ADDENDUM 1

Registry Building Exterior Lighting Mike Monroney Aeronautical Center Project No. OCAT WRWA 2428

JUNE 18, 2024

REGISTRY BUILDING EXTERIOR LIGHTING MIKE MONRONEY AERONAUTICAL CENTER PROJECT NO. OCAT WRWA 2428	FRANKFURT-SHORT-BRUZA ASSOCIATES, P.C. 5801 BROADWAY EXTENSION SUITE 500 OKLAHOMA CITY, OKLAHOMA, 73118
---	--

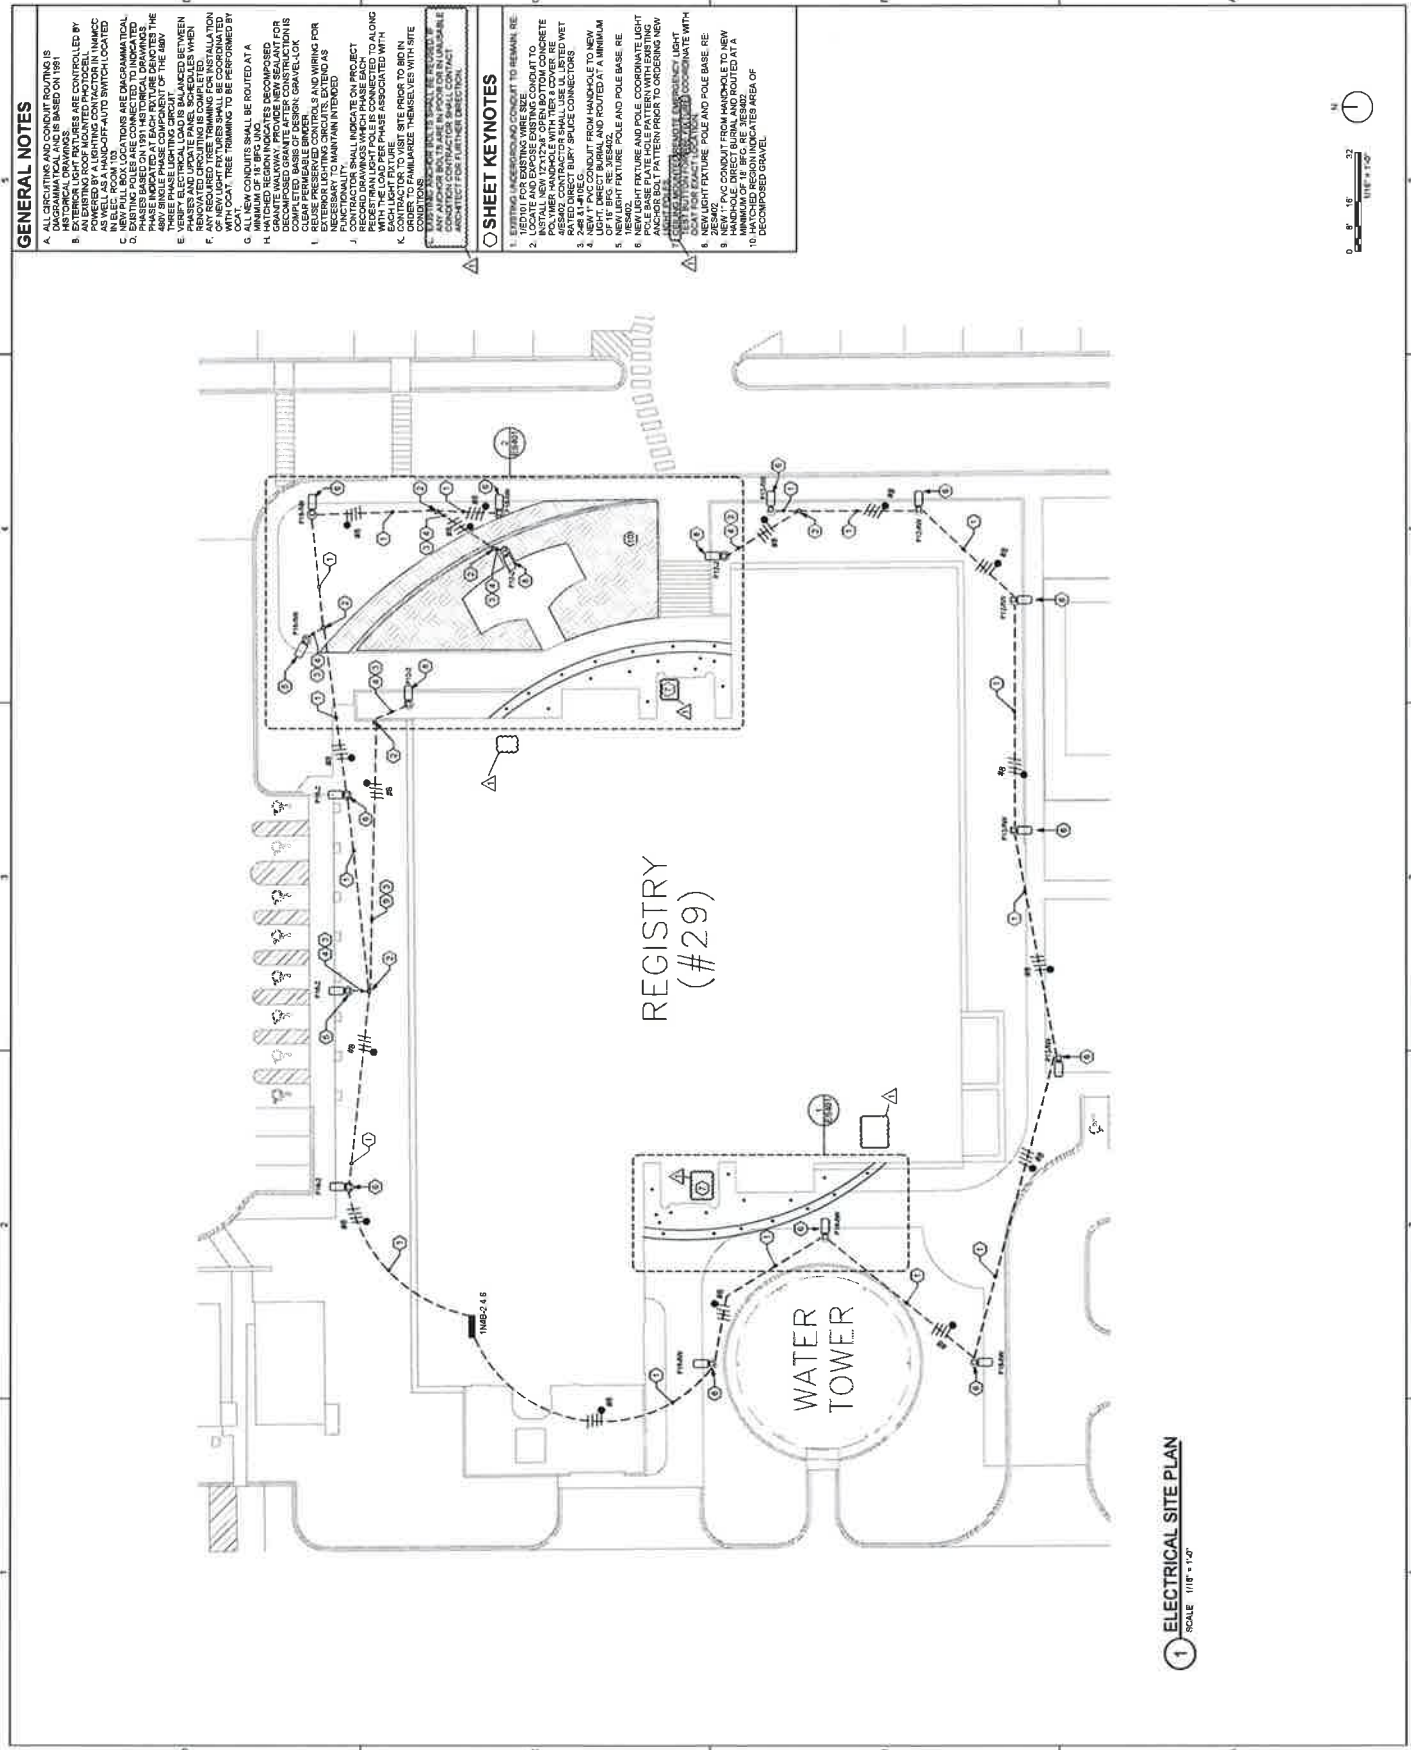
- ITEM 1-1 Sheet ES101 ELECTRICAL SITE PLAN revisions:
- General Note 'L' added per Addendum 01.
 - Sheet Keynotes: Keynotes #7 revised to account for ceiling mounted remote emergency light test button.

- Detail 1: Revised keynote locations for emergency light test buttons from east & west lobbies into the east & west vestibules.
- ITEM 1-2 ES401 ELECTRICAL ENLARGED PLANS revisions:

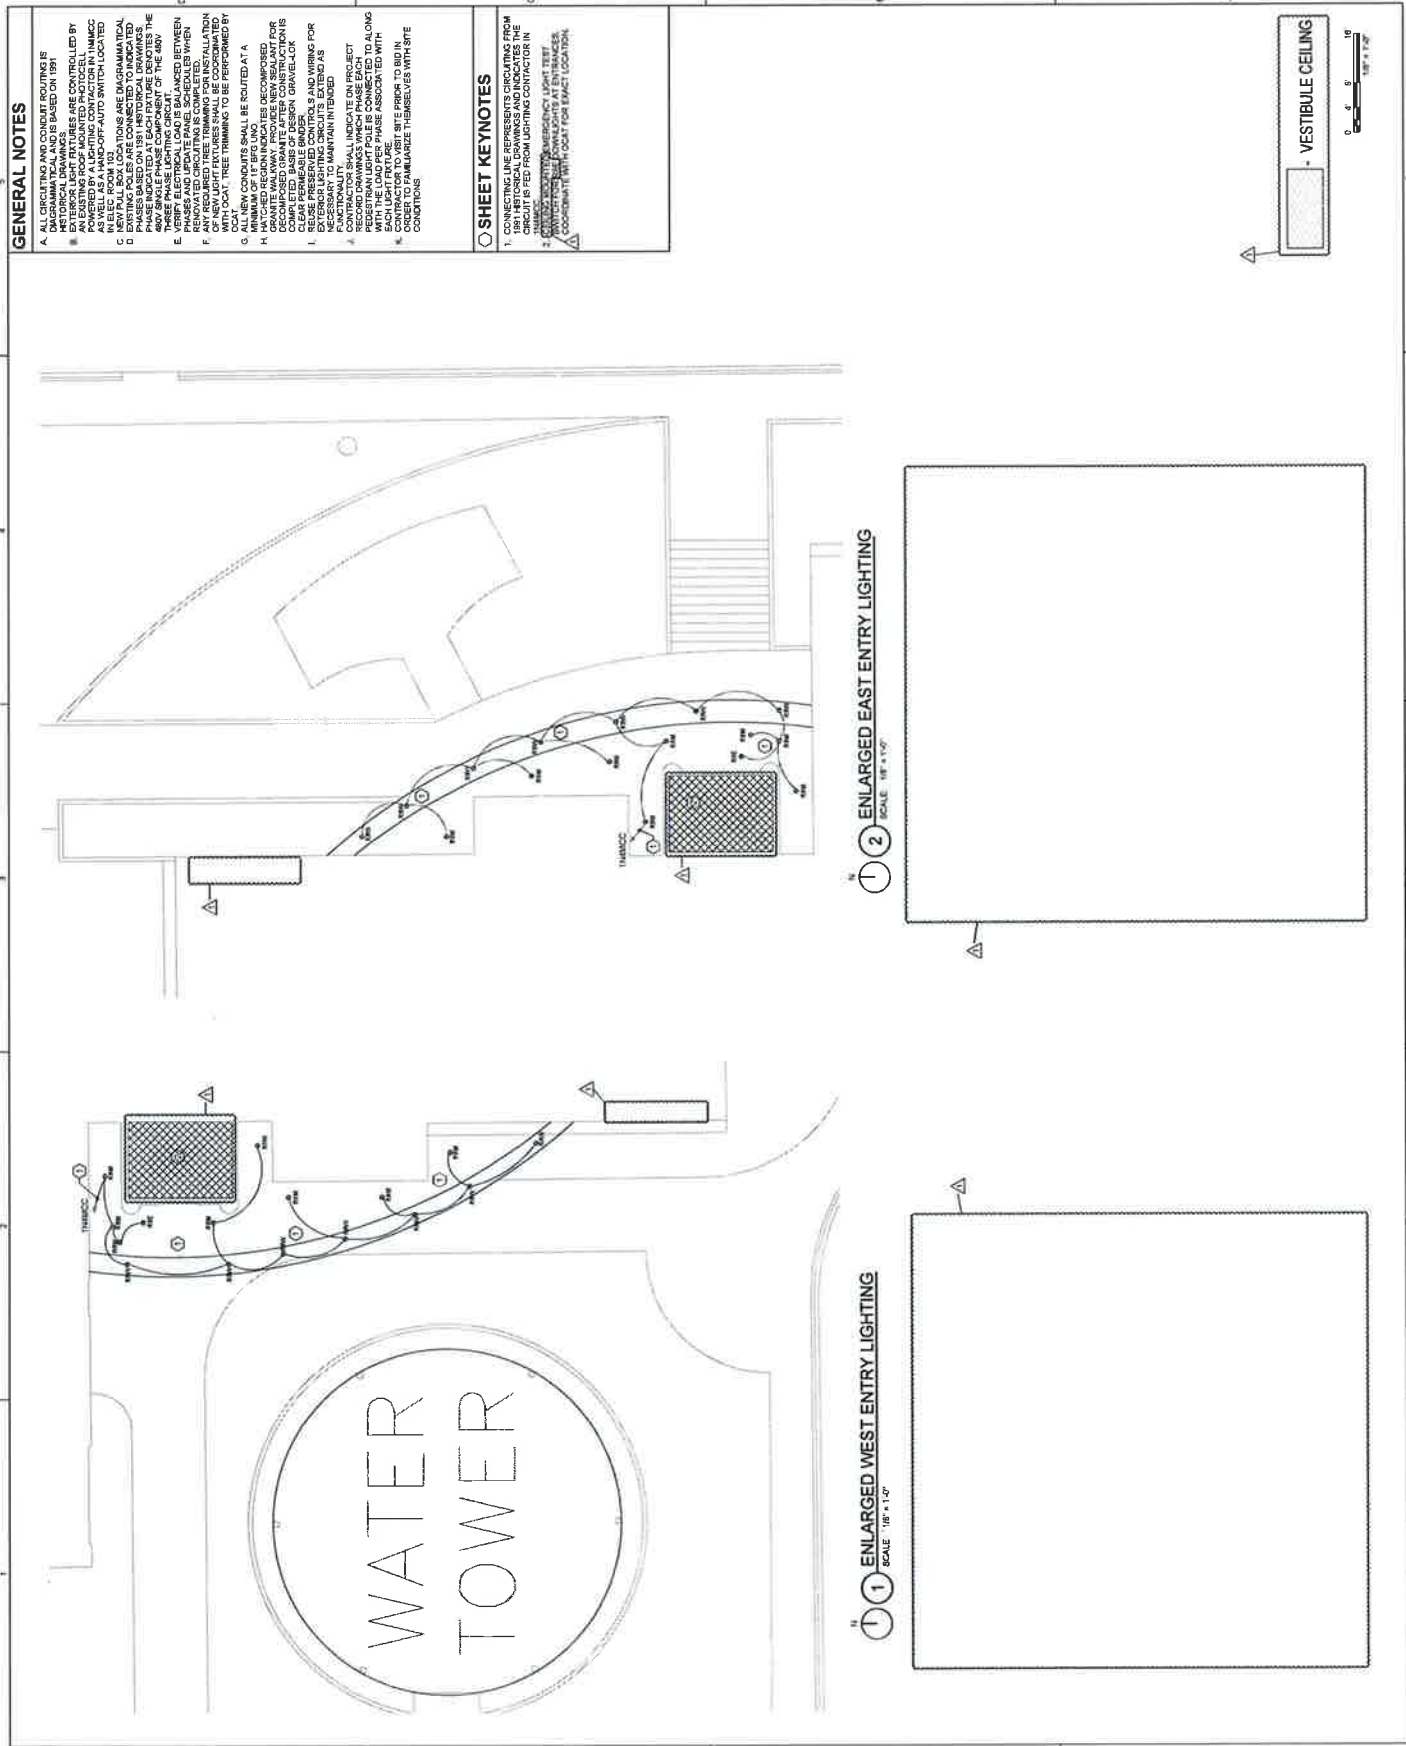
- Sheet Keynotes: Keynote #2 revised to account for ceiling mounted remote emergency light test button.
 - Detail 1: Revised keynote location for emergency light test button from west lobby into the west vestibule and added hatching to vestibule.

- Detail 2: Revised keynote location for emergency light test button from east lobby into the east vestibule and added hatching to vestibule.
 - Detail 3 removed.

- Detail 4 removed.
 - Added vestibule hatching legend.
- ITEM 1-3 ES402 ELECTRICAL LIGHTING FIXTURE SCHEDULE & DETAILS revisions: Updated the R8 fixtures' part number and description in light fixture schedule to account for the remodel kit.
